UNITED STATES PATENT AND TRADEMARK OFFICE

| APPLICATION NO. | FILING DATE | FIRST NAMED INVENTOR | ATTORNEY DOCKET NO. | CONFIRMATION NO. |
|-----------------|-------------|----------------------|---------------------|------------------|
| 10/732,970 | 12/11/2003 | Theodore W. Houston | TI-35974 | 8532 |

Office Action Summary

DETAILED ACTION

REPLACEMENT
SHEET 1

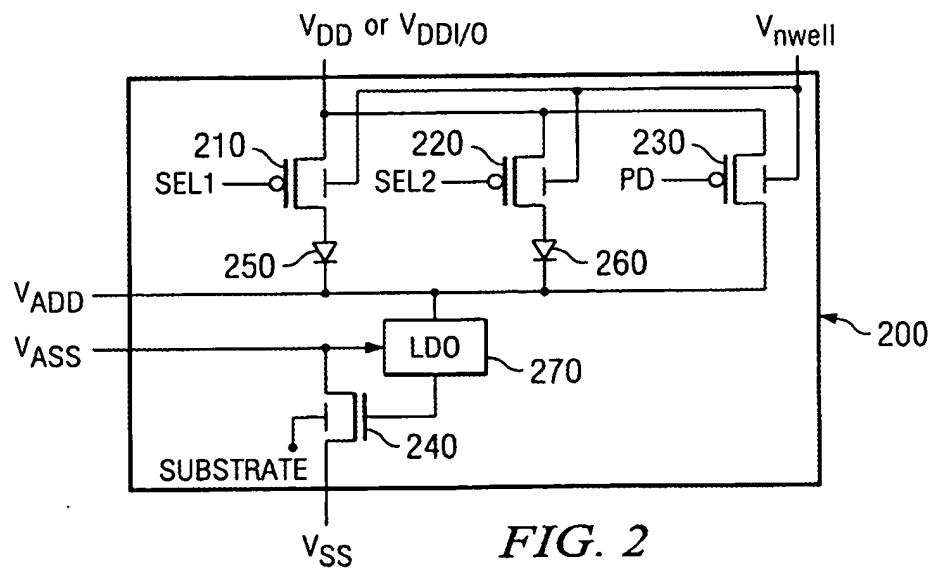
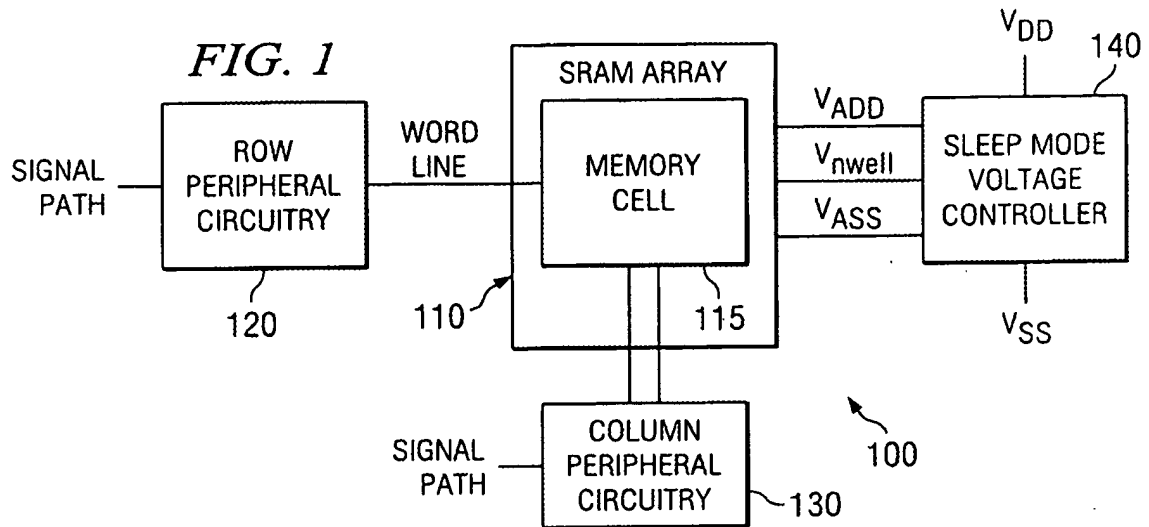
1. The drawings were received on 11/03/05. These drawings have been approved.
2. The drawings are objected to as failing to comply with 37 CFR 1.84(p)(5) because they include the following reference character(s) not mentioned in the description: **VDD or VDDI/O in Fig. 2 (it should be noted that the specification only discloses that n-well may be connected to a high input/output voltage VDDI/O at about 1.8 volts while the high operating voltage VDD is at about 1.2 volts in lines 21-23, page 19 not mentions any thing how the VDD and the VDDI/O are interswitchable.** Corrected drawing sheets in compliance with 37 CFR 1.121(d), or amendment to the specification to add the reference character(s) in the description in compliance with 37 CFR 1.121(b) are required in reply to the Office action to avoid abandonment of the application. Any amended replacement drawing sheet should include all of the figures appearing on the immediate prior version of the sheet, even if only one figure is being amended. Each drawing sheet submitted after the filing date of an application must be labeled in the top margin as either "Replacement Sheet" or "New Sheet" pursuant to 37 CFR 1.121(d). If the changes are not accepted by the examiner, the applicant will be notified and informed of any required corrective action in the next Office action. The objection to the drawings will not be held in abeyance.

3. The drawings are objected to under 37 CFR 1.83(a) because they fail to show: **how the n-well may be connected to a high input/output voltage VDDI/O at about 1.8 volts while the high operating voltage VDD is at about 1.2 volts as described**

in lines 21-23, page 19 of the specification since Fig. 2 of the present invention does not show any switch or device is used for connecting the Vnwell voltage to the high input/output voltage VDDI/O or the high operating voltage VDD; how the first switch 210 and the second switch 220 may be connected to the high input/output voltage VDDI/O as describe in lines 1-3, page 20 of the present invention since all three transistors 210, 220 and 230 are commonly connected to VDD or VDDI/O without showing any circuit to break this connection. Any structural detail that is essential for a proper understanding of the disclosed invention should be shown in the drawing. MPEP § 608.02(d). Corrected drawing sheets in compliance with 37 CFR 1.121(d) are required in reply to the Office action to avoid abandonment of the application. Any amended replacement drawing sheet should include all of the figures appearing on the immediate prior version of the sheet, even if only one figure is being amended. The figure or figure number of an amended drawing should not be labeled as "amended." If a drawing figure is to be canceled, the appropriate figure must be removed from the replacement sheet, and where necessary, the remaining figures must be renumbered and appropriate changes made to the brief description of the several views of the drawings for consistency. Additional replacement sheets may be necessary to show the renumbering of the remaining figures. Each drawing sheet submitted after the filing date of an application must be labeled in the top margin as either "Replacement Sheet" or "New Sheet" pursuant to 37 CFR 1.121(d). If the changes are not accepted by the examiner, the applicant will be notified and

4. The drawings are objected to under 37 CFR 1.83(a). The drawings must show every feature of the invention specified in the claims. Therefore, **the feature “wherein said array high supply voltage VADD and said array low supply voltage VASS are provided concurrently” as newly recited in claims 1, 14 and 24; the features as recited in claims 11 and 23 (it should be noted that in Fig. 1 of the present invention, SRAM array 110 is receiving VADD, Vnwell and VASS voltages; in Fig. 2 of the present invention, the detailed sleep mode voltage controller 200 does not provide the n-well voltage Vnwell and the substrate voltage SUBSTRATE but it is clearly receiving the n-well voltage Vnwell and the substrate voltage SUBSTRATE; p-channel transistors 210, 220 and 230 is back biased the same n-well voltage Vnwell; n-channel transistor 240 is back biased by the substrate voltage SUBSTRATE); the minimum voltage across said SRAM array that is sufficient for data retention as recited in claims 12-13 must be shown or the feature(s) canceled from the claim(s).** No new matter should be entered.

Corrected drawing sheets in compliance with 37 CFR 1.121(d) are required in reply to the Office action to avoid abandonment of the application. Any amended replacement drawing sheet should include all of the figures appearing on the immediate prior version of the sheet, even if only one figure is being amended. The figure or figure number of an amended drawing should not be labeled as “amended.” If a drawing figure is to be canceled, the appropriate figure must be removed from the replacement sheet,
